City of El Paso – City Plan Commission Staff Report

Case No:	SUSU14-00023 – Kern View Estates Unit Two Replat A
Application Type:	Resubdivision Combination
CPC Hearing Date:	February 12, 2015
Staff Planner:	Nelson Ortiz, (915) 212-1606, ortiznx@elpasotexas.gov
Location:	East of Stanton and North of San Mateo
Acreage:	15.5757 acres
Rep District:	1
Existing Use:	Vacant
Existing Zoning:	R-3 / P-R 1/c (Residential / Planned Residential/condition)
Proposed Zoning:	R-3 / P-R 1/c (Residential / Planned Residential/condition)
Nearest Park:	Mission Hills Park (.23 mile)
Nearest School:	Mesita Elementary School (.70 mile)
Park Fees Required:	$83,570.00
Impact Fee Area:	N/A
Property Owner:	Piedmont Group, LLC
Applicant:	Piedmont Group, LLC
Representative:	Brock & Bustillos, Inc.

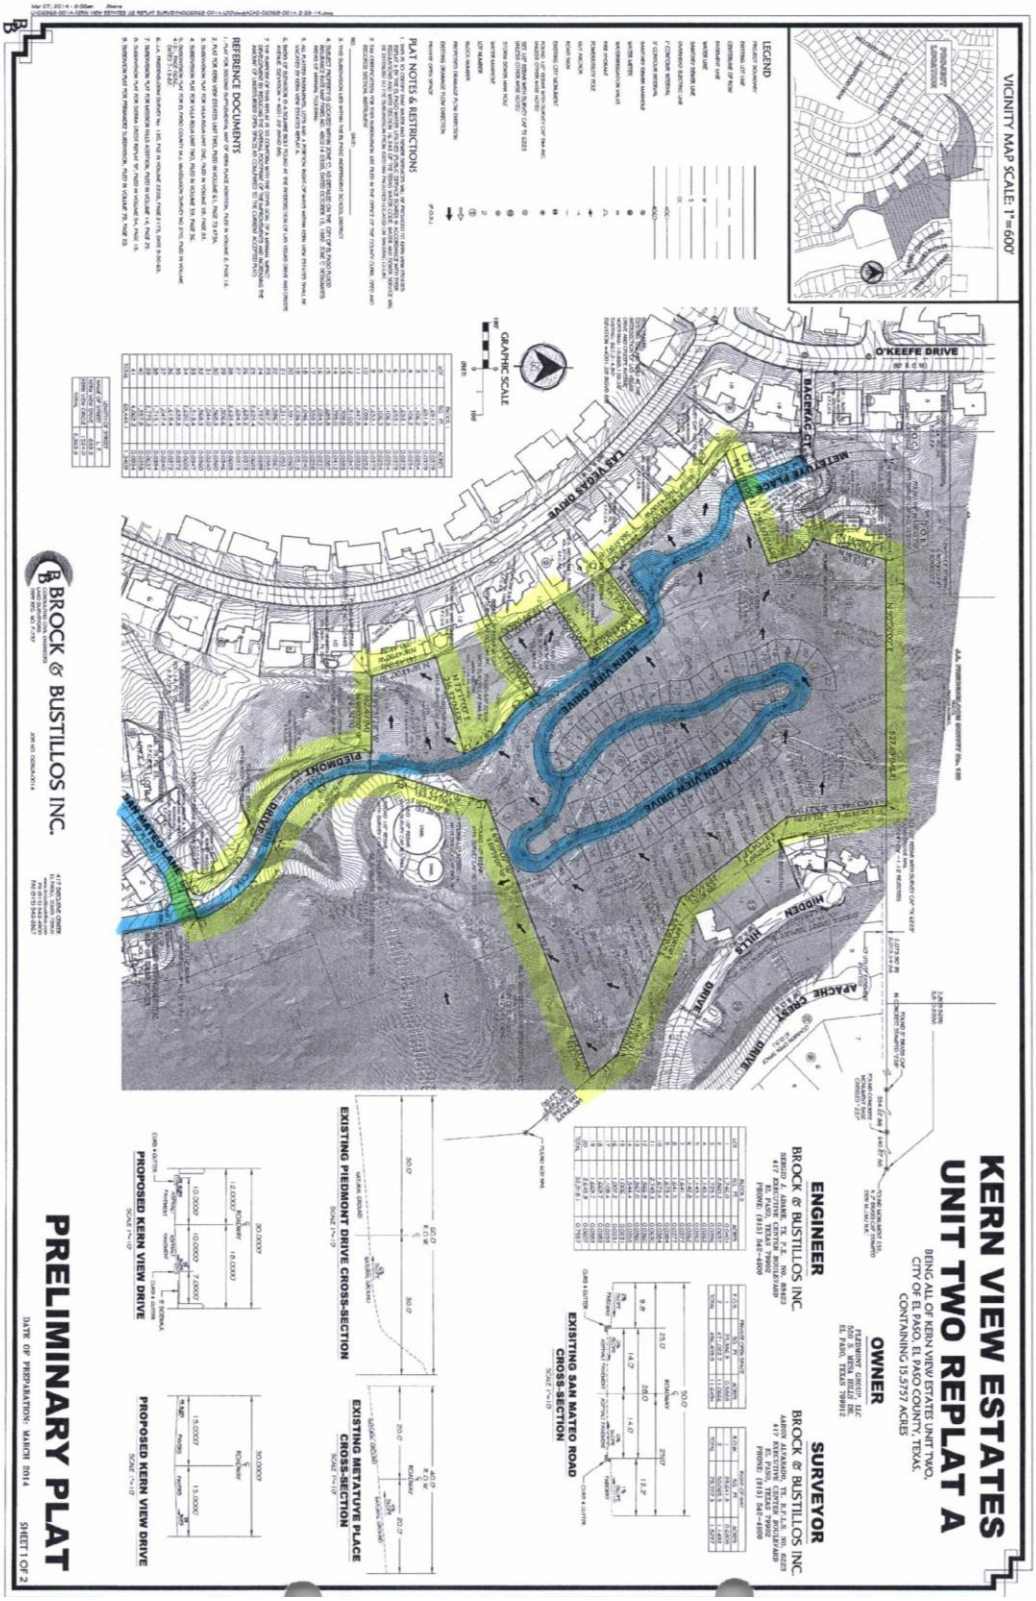
1. Verify line of sight for proposed monuments along drives.
2. On the street cross-sections, need to label the slope and direction.
3. Provide cross section for proposed future private Piedmont Drive.
4. Show proposed drainage flow patterns and contours on the preliminary plat. Identify the discharge location for all storm-water runoff.
5. Verify safe conveyance of the existing watercourse through the developed subdivision and show that all downstream storm-water management facilities have sufficient capacity to carry the additional runoff.
6. Provide a note on the plat indicating the entity responsible for maintenance of private drainage easement and private open space.
